STAFF RECOMMENDATION

**510 Fairfax Avenue
December 16, 2015**

Application: New construction— addition
District: Hillsboro-West End Neighborhood Conservation Zoning Overlay
Council District: 18
Map and Parcel Number: 10410019200
Applicant: Tyler LeMarinel, Allard Ward Architects
Project Lead: Melissa Baldock, melissa.baldock@nashville.gov

<p>Description of Project: Application is to construct an addition that is taller and wider than the historic structure.</p> <p>Recommendation Summary: Staff recommends approval of the project with the following conditions:</p> <ol style="list-style-type: none">1. Staff approve the final details, dimensions and materials of windows and doors prior to purchase and installation; and,2. The HVAC shall be located behind the house or on either side, beyond the mid-point of the house; and3. Staff approve the roof color and masonry color, dimensions and texture. <p>With these conditions, staff finds that the addition meets Sections II.B. of the <i>Hillsboro-West End Neighborhood Conservation Zoning Overlay: Handbook and Design Guidelines</i>.</p>	<p>Attachments A: Photographs B: Site Plan C: Elevations</p>
---	--

Figure 1. 510 Fairfax Avenue

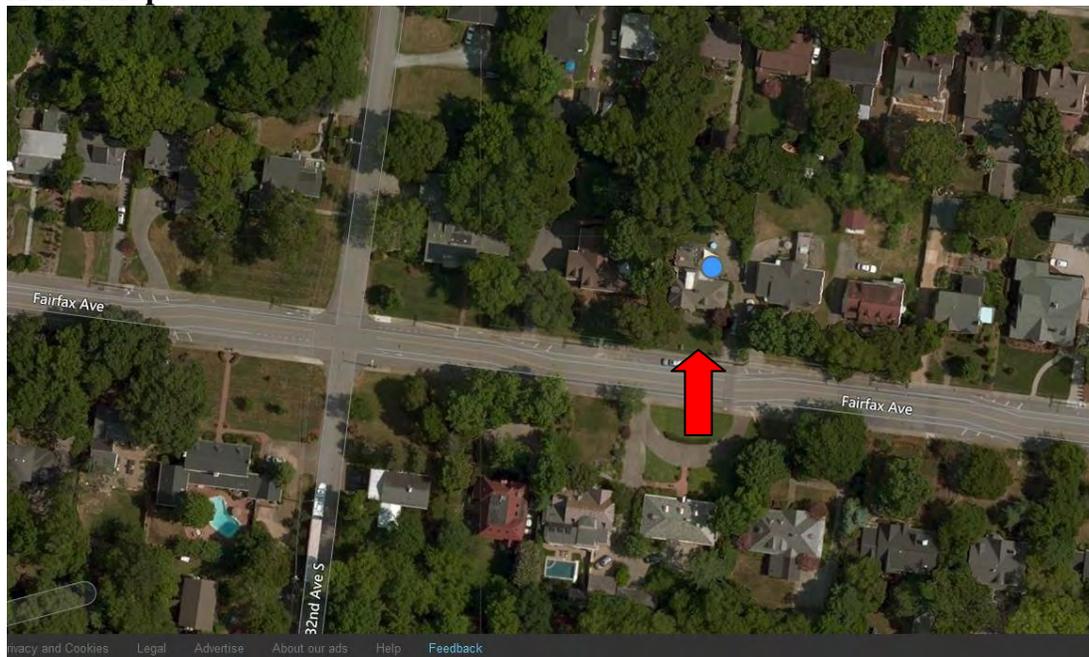
Background: 510 Fairfax is a c. 1935 stone Tudor Revival style house (Figure 1). It contributes to the historic character of the Hillsboro-West End Neighborhood Conservation Zoning Overlay.

Figure 2. The addition attaches to an enclosed former porch that is inset from the back corner of the house.

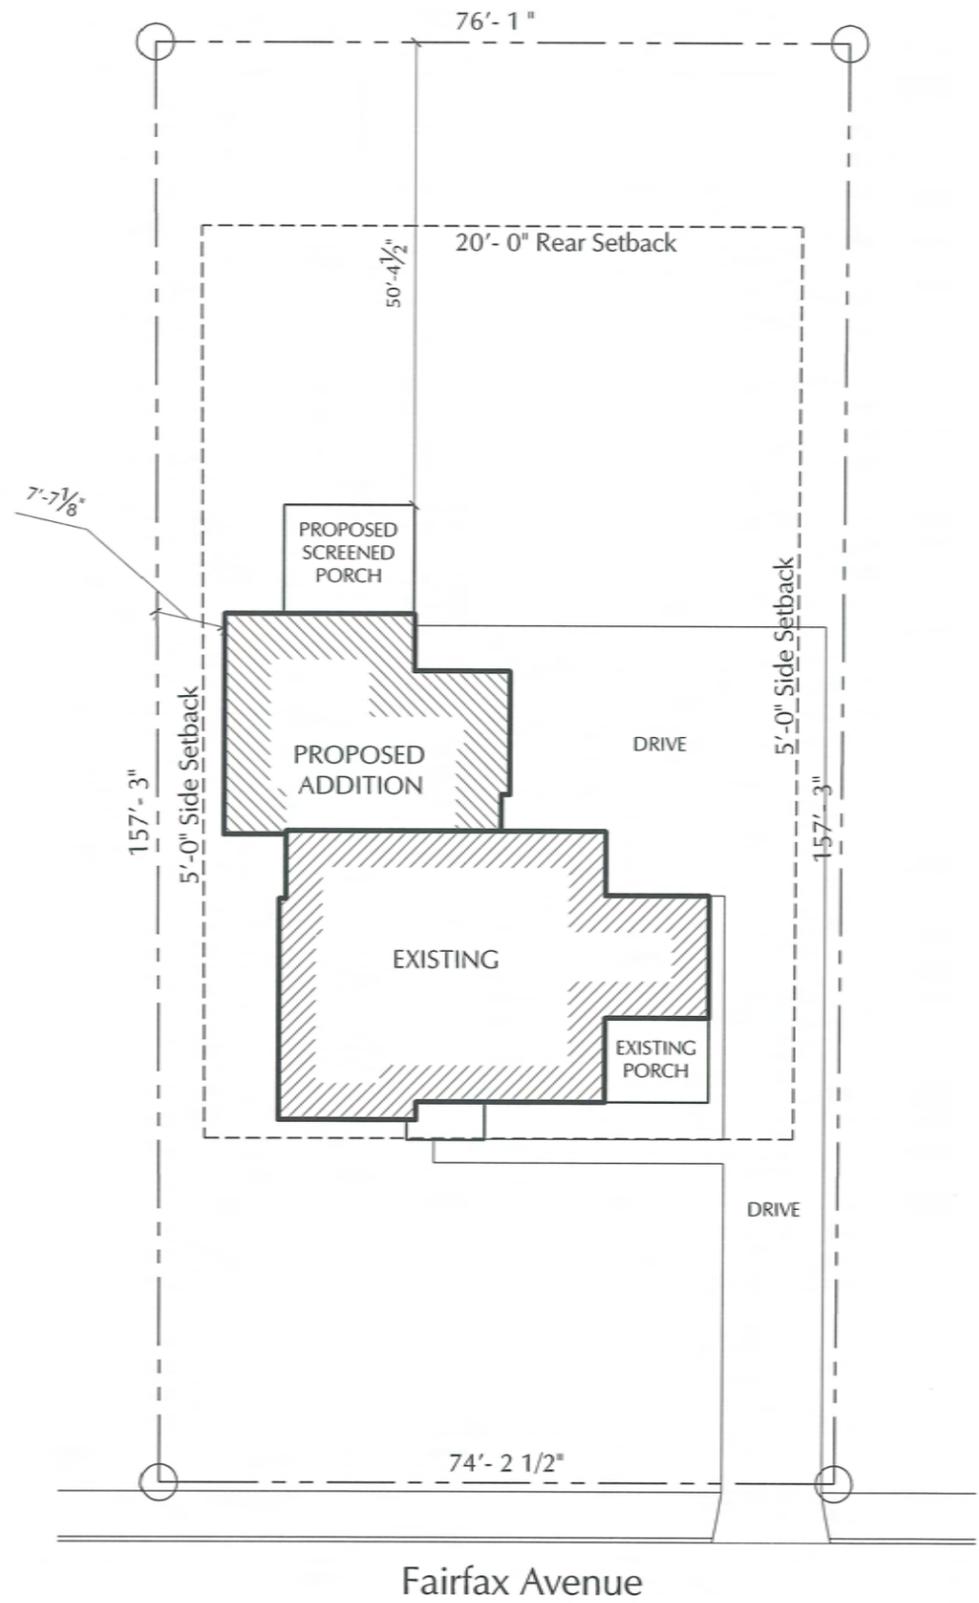
Location & Removability: The addition is located entirely behind the historic house. It attaches to a portion of the rear of the house that was formerly a porch and has since been enclosed (Figure 2). Although the Commission typically asks for an inset of one to two feet (1'-2') at the back corner of the house, the addition does not inset at all, but rather extends out to be six feet (6') wider than the historic house. Staff finds the lack of an inset to be appropriate in this instance because the existing porch has been enclosed in more recent years and the addition already sets in approximately one foot (1') from the back corner of the house, and therefore the historic back corner of the house has been preserved. The addition is adequately distinguished from the historic house, yet could be removed in the future without detrimentally affecting the historic character of the house. Staff therefore finds that the project meets Sections II.B.2.a and e. of the design guidelines.
